Permit ID: C2011003F
Revision Type: N/A
Permitting Action: Deficiency
Subject: Third Round Acceptability Deficiency

The Department of Environmental Quality (DEQ) has completed its acceptability review regarding Western Energy Company's (WECO) application for SMP C2011003F. The following deficiencies must be adequately addressed before DEQ can determine the application acceptable:

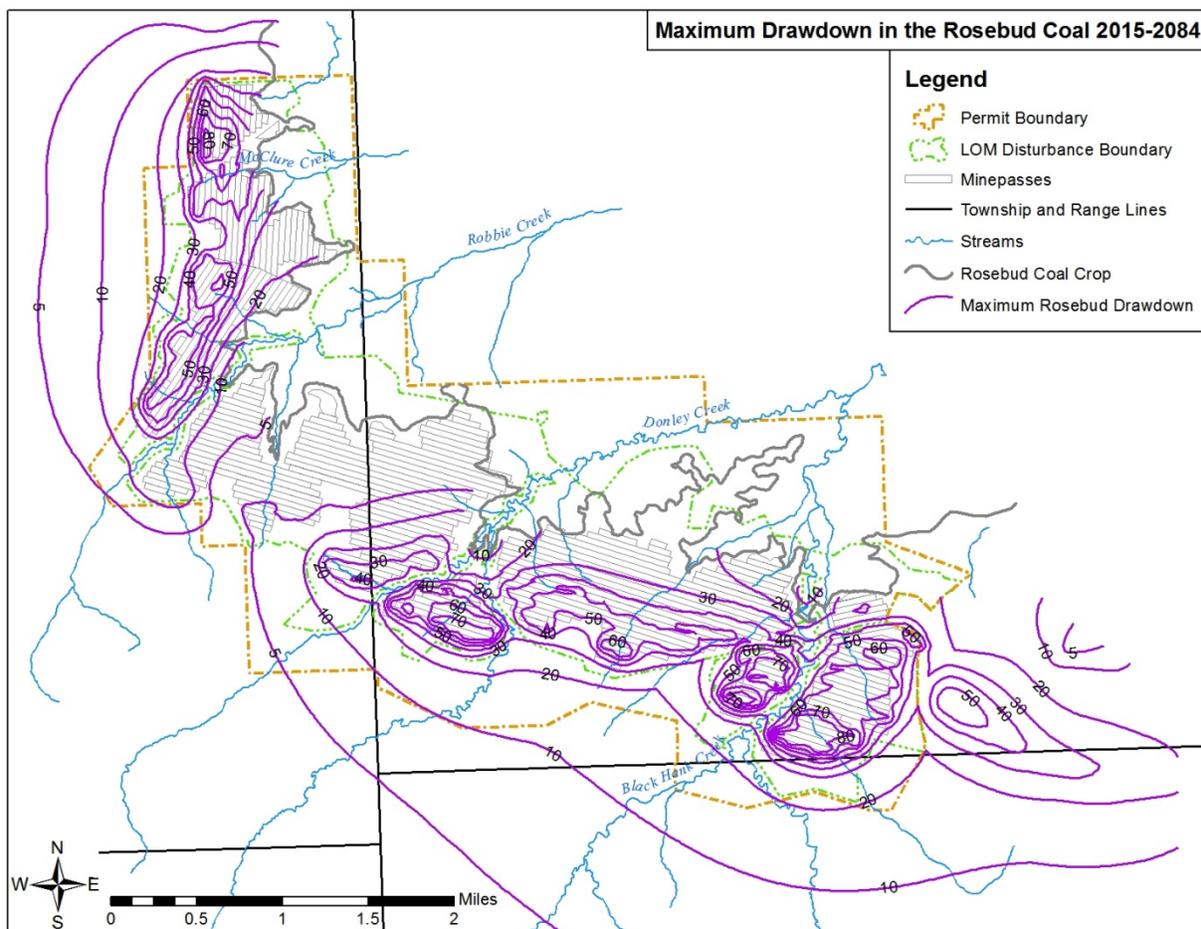
ARM 17.24.314(3): In reviewing the digital drawdown data (see map below) provided for the Area F model (Appendix I-B), DEQ noted that the model predicts no drawdown from the majority of mining conducted between Robbie and Donley Creeks. Additionally, the simulated mine discharges in Appendix I-B, Table I-2 and Table I-3, show little to no water being removed by the drains simulating the mine cuts during the period this area is being mined (2022-2026). It appears that the model is simulating a lack of water in the Rosebud coal in this area in the premine condition, but this cannot be verified without evaluating the model datasets. Water level monitoring at wells WR-236 and WR-237 show saturated thicknesses of approximately one to seven feet, but these wells are located near the coal crop and saturated thickness would be expected to increase away from the coal line. Please provide a detailed explanation for the lack of drawdown in this area.

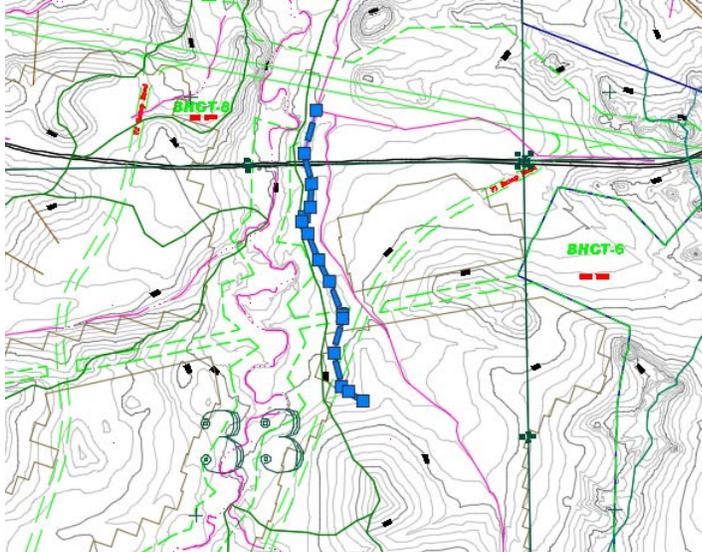
ARM 17.24.634(1)(i) The postmine stream channel that is highlighted below, located in Sections 28 and 33, should be deleted from Exhibit B, Post Mine Topography Map. This stream channel does not exhibit characteristics that will blend with the undisturbed drainage system below the area to be reclaimed.
